MEMORANDUM

Reference: PPSSWC-289 (Council reference: DA22/1080)

Subject: Update on additional material uploaded to the Planning Portal on 26 June 2023 – Proposed Warehouse Development at No. 68 Lockwood Road, Erskine Park

Figure 2 (above): Extract from DA21/0801

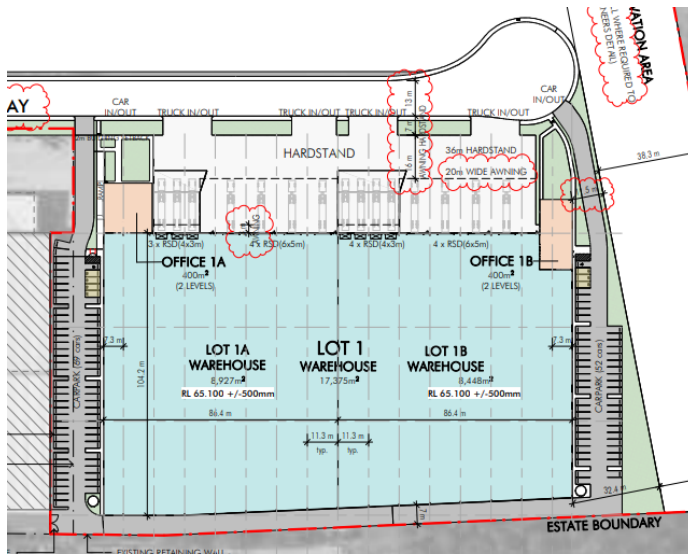
- The proposed awning is inconsistent with other approved developments within the vicinity of the site and within the broader Western Sydney Employment Area. The following are extracts (**Figure 2 and Figure 3**) from the approved Site Plans, of DA21/0801 and DA22/0131 (which was approved by SWCPP). Both examples include 20m deep awnings which are each setback a minimum of 23m from their respective street frontage.

- Council recommends that the proposed super awning be amended to comply with the minimum 15m building setback requirement of the DCP.
